08002
14 October 2009

**JACFIN WAREHOUSE PROJECT (APPLICATION 07_0153)
TEMPLAR ROAD, ERSKINE PARK**

Amended Design – Ecological Issues

Proposed offset on Lot 5 for the Jacfin warehouse in Erskine Park

Figure 1

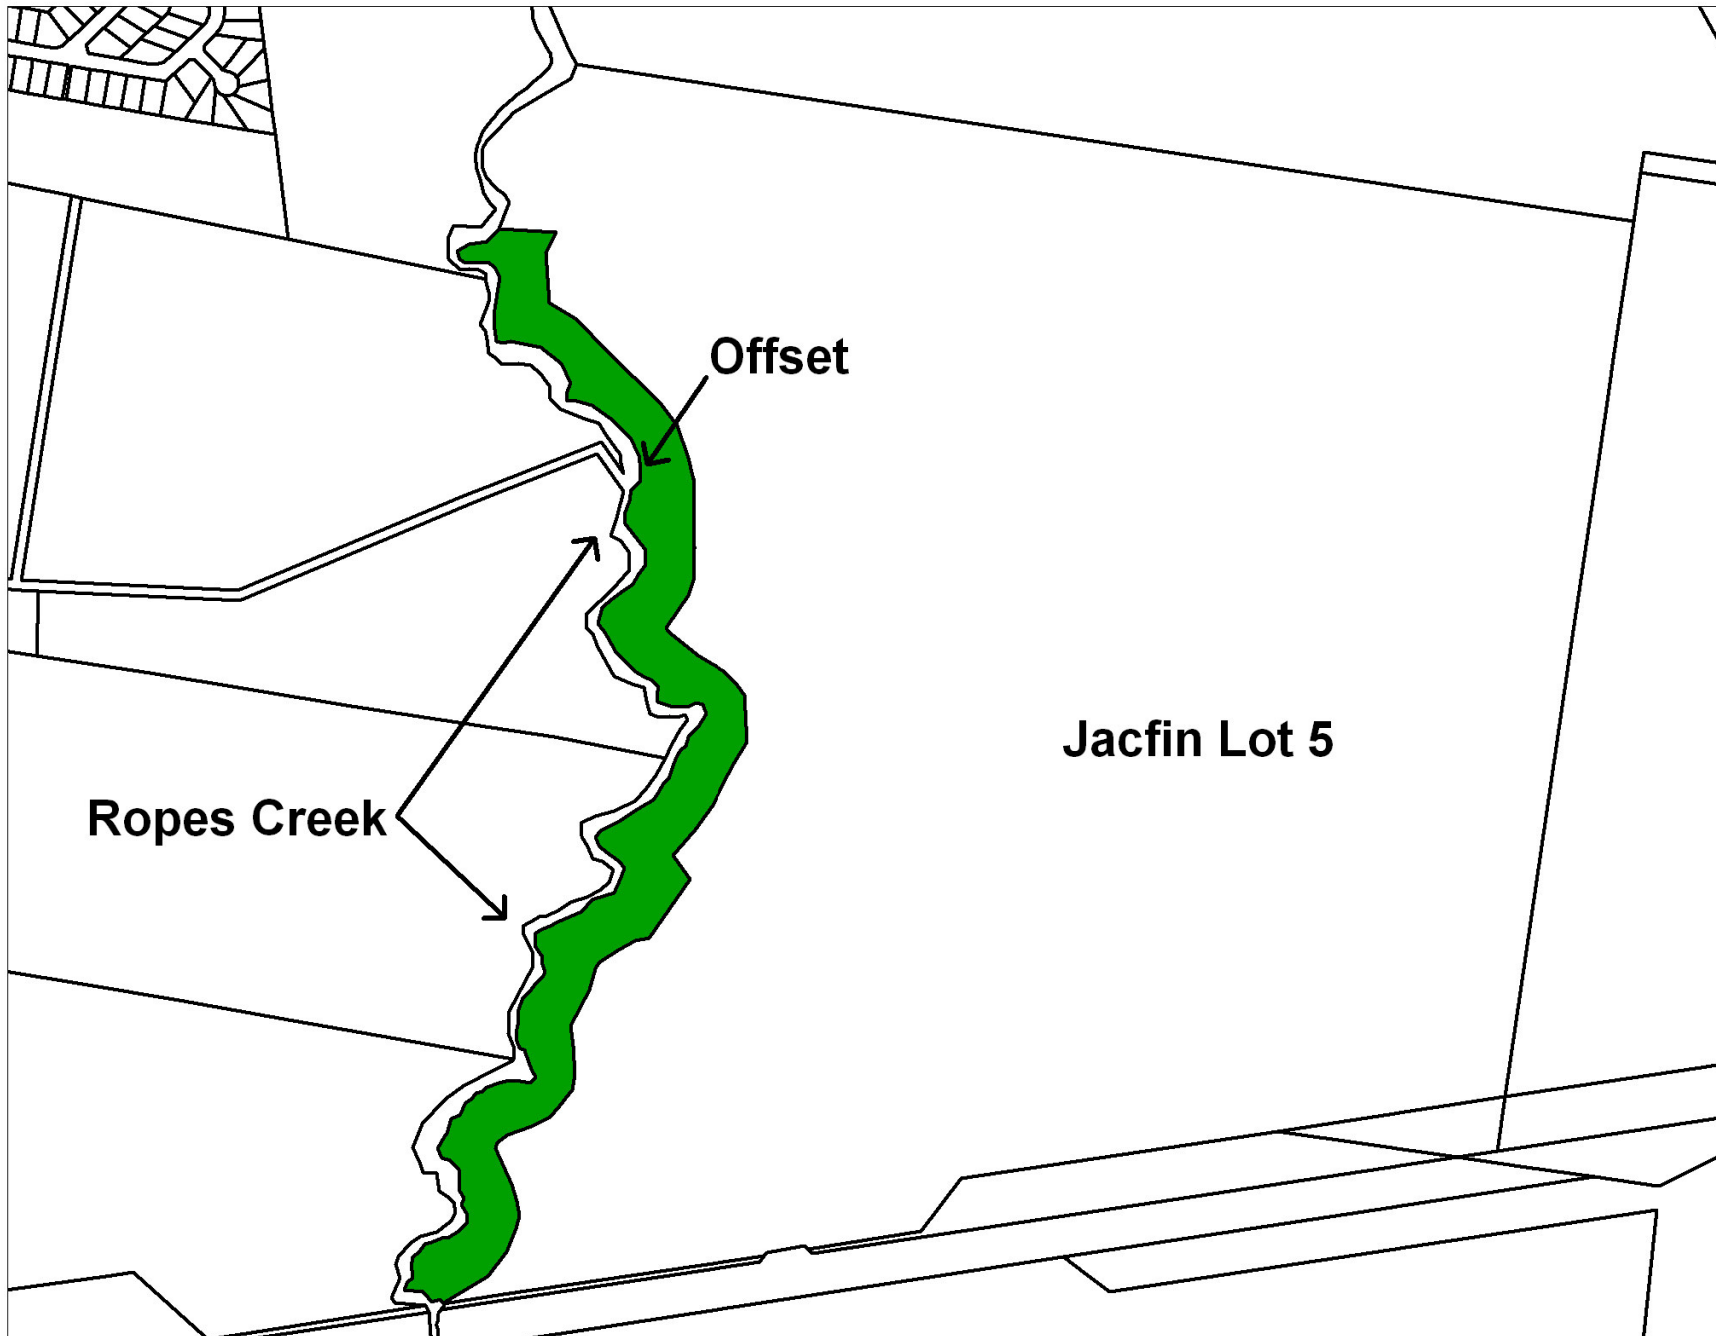
Additionally, a revised plan has been prepared by Whelans Insites that shows the location of the proposed offset area of land adjacent to Ropes Creek in Lot 5 DP 262211 (Appendix B). This plan clearly identifies the location of the offset area, which is a total of 7 hectares.

- Offset E2 (7 hectares)
Final eastern boundary of offset land to be resolved with future industrial development design.
